**TO:** City Council  
**FROM:** Nathan Fuerst, Consulting Planner  
Jenni Faulkner, Consulting Planner  
**SUBJECT:** **Easton Village 6<sup>th</sup> Addition – Final Plat**  
**REVIEWED BY:** Kristina Handt, City Administrator

Re: Easton Village 6th Addition  
Final Plat/Plan Review

ADDRESS: 11781 34TH STREET NORTH

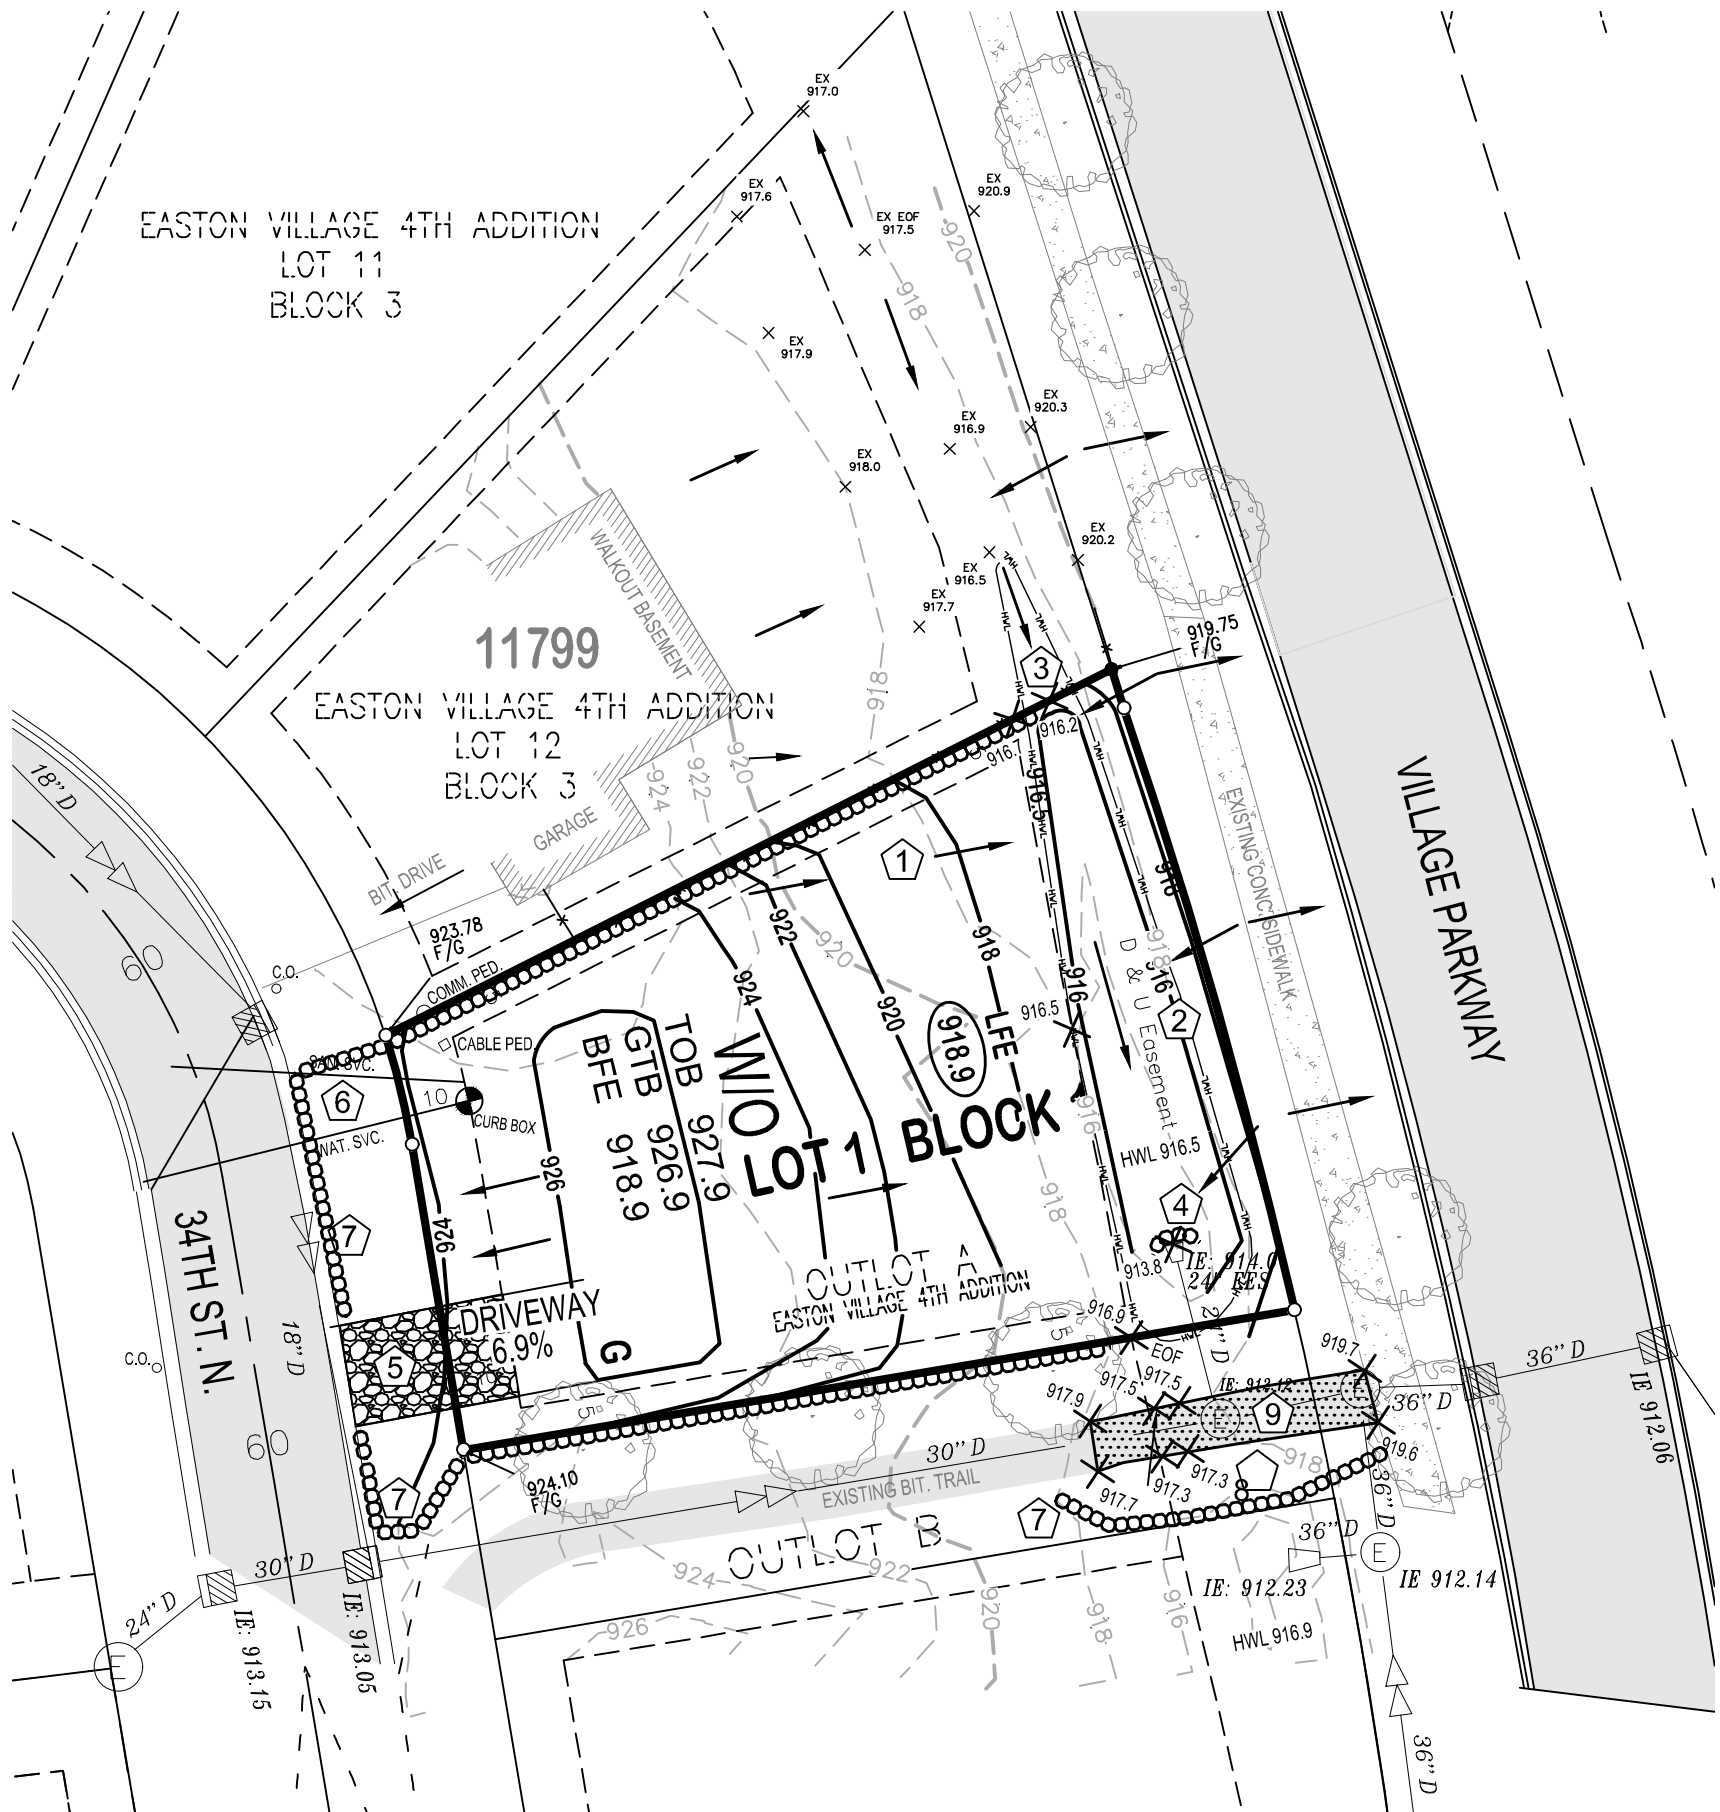
3. Final Plat approval must be contingent upon the project reconstructing portions of the adjacent trail to ensure positive drainage away from the trail, and to ensure there is no post construction erosion along the trail or within city owned Outlot B. The proposed plans dated July 7, 2023, include the trail reconstruction as required.

4. Final Plat approval must be contingent upon as-built verification of the reconstructed trail to ensure the 917.5 EOF has been established.
5. Final Plat approval must be contingent upon the rear yard drainage swale being constructed in strict accordance with the approved plans with as-built shots located on the rear lot easement line to demonstrate that the 100-year HWL of 916.5 is fully within the drainage easement.

- 1 OUTLOT A, EASTON VILLAGE 4TH ADDITION TO BE RECORDED AS LOT 1, BLOCK 1 EASTON VILLAGE 6TH ADDITION, WITH NO CHANGE TO EXISTING EASEMENTS
- 2 CORRECT EXISTING SWALE TO MATCH THE ORIGINAL PLANNED SWALE OF THE 4TH ADDITION, GRADE TO CONTOURS AS SHOWN
- 3 LOT TO NORTH, L12, B3, 4TH ADDITION IS UNDER CONSTRUCTION, CONTRACTOR TO MATCH ELEVATION AT PROPERTY LINE PER ORIGINAL GRADING PLAN FOR THE 4TH ADDITION
- 4 MATCH GRADE AT EXISTING FLARED END STORM INLET. PROTECT EXISTING FLARED END INLET WITH SILT FENCING DURING HOME CONSTRUCTION)

- 5 INSTALL ROCK ENTRANCE DURING CONSTRUCTION
- 6 PROTECT EXISTING WATER AND SANITARY SEWER SERVICES
- 7 INSTALL SILT FENCE PRIOR TO THE START OF CONSTRUCTION AT ALL DOWNSTREAM GRADES
- 8 REMOVE SOD AND LOWER ELEVATION FOR 3'-FT AREA TO ALLOW FOR DRAINAGE OFF OF TRAIL TO FLOW TO SOUTH. REPAIR WITH TOPSOIL SEED AND BLANKET AS REQUIRED.
- 9 REMOVE & REPLACE BIT TRAIL TO RE-ESTABLISH 4' WIDE OF - SEE CITY TRAIL DETAIL
